Economic and Social Council

Standardization of technical and safety requirements in inland navigation: Recommendations on Harmonized Europe-Wide Technical Requirements for Inland Navigation Vessels (resolution No. 61, revision 2)

> Amendments to the annex to resolution No. 61 on Recommendations on Harmonized Europe-Wide Technical Requirements for Inland Navigation Vessels, revision 2

Amendments to the Recommendations on Harmonized Europe-Wide Technical Requirements for Inland Navigation Vessels (annex to resolution No. 61, revision 2)

III. Amendment proposal to appendix 3, "Safety signs and signals to be used on board inland navigation vessels"4

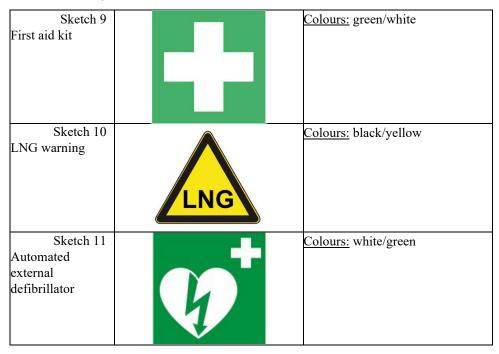
15-8.10 Passenger vessels must be equipped with at least one automated external defibrillator. Its location is indicated by a symbol for 'automated external defibrillator' in accordance with sketch 11 of appendix 3, having a side length of at least 10 cm. The automated external defibrillator must be maintained in accordance with the manufacturer's instructions.

9. In the end, add
